Re: EB-2025-0297 Application by Ontario Power Generation Inc. and DNNP LP by its general partner, DNNP GP Inc., (together, the “Applicants”) for an order or orders relating to payment amounts for prescribed generating facilities (the “Application”) – Interrogatory Responses- Staff Expert IRs

Attachment 1 – Interrogatory Responses – Staff Expert IRs

21 **Figure 1: Residuals vs Fitted values - OM&A model**

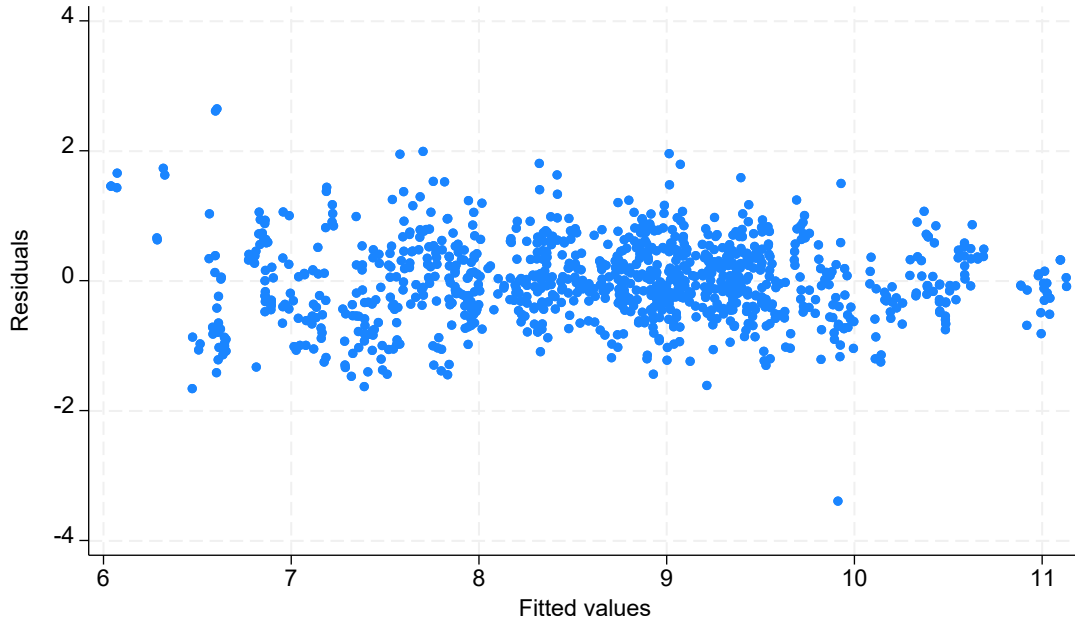
- b) Please confirm that the econometric models use panel data which, by definition, cause the estimates of the model standard errors exhibit heteroskedasticity, severe serial correlation, and spatial correlation. If confirmed, please explain why the non-robust p-value has any meaning at all.

- 4
5 a) LEI did not present a study of “U.S. distributors” as implied in the wording of the
6 question; LEI assumes this is a typographical error. For LEI’s total cost
7 benchmarking study of hydroelectric generation companies, the values in column I
8 of the “US Price Indices” tab and columns S, T, and U of the “CA Price Indices” tab
9 in the “Benchmarking Workpapers_Redacted” file are related to reported inflation
10 index values, which vary over time and whether a specific hydroelectric operator is
11 a US or Canadian entity.
12
13 b) LEI’s econometric study employs a panel regression. However, panel data does not
14 necessarily exhibit heteroskedasticity, serial correlation, and spatial correlation in
15 all cases as suggested in the question. The presence of these issues depends on
16 the specific combination of data being used for the analysis. For the models
17 presented in LEI’s analysis, randomness is indeed observed in the residuals

18 against the fitted values, as demonstrated in Figure 1 (for the OM&A model) and
19 Figure 2 (for the OM&A + SC model) below.
20
